RE: Pasture Sediment
Pond
ACT/007/007 #4
Carbon County, Utah

Thank you for reviewing the Pasture sediment pond design. The items mentioned in your letter of August 11, 1983 are addressed in this letter or the material is enclosed.

Figure 7A.3b. Pipe full nomograph - corrugated metal, n = 0.024. (adapted from Portland Cement Association, 1962)

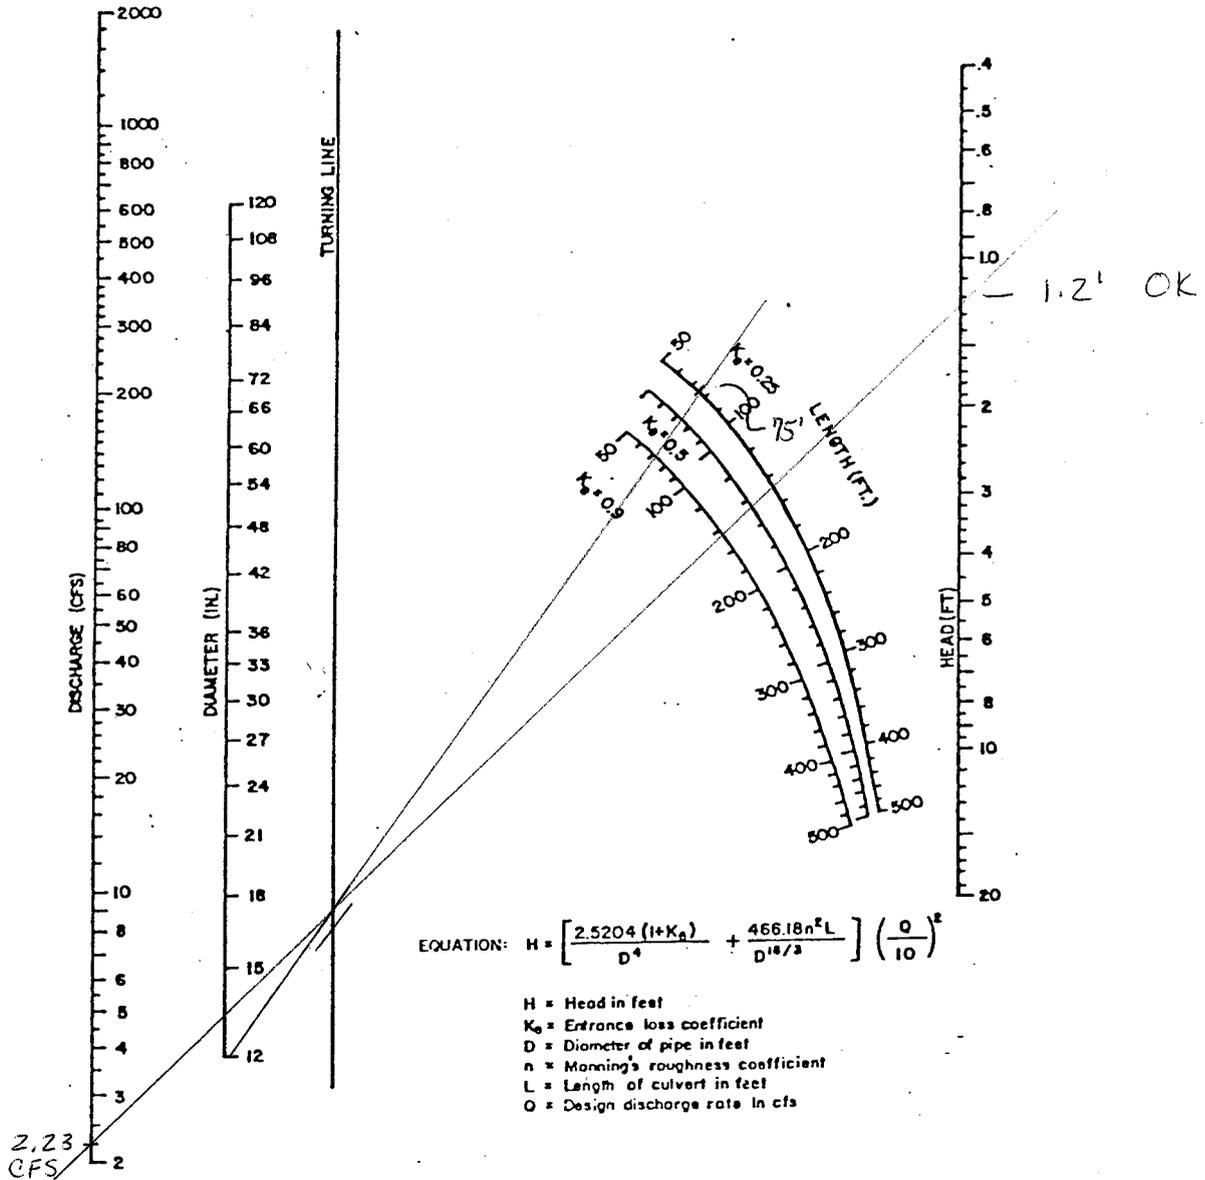
Haul road culvert use 12" CMP
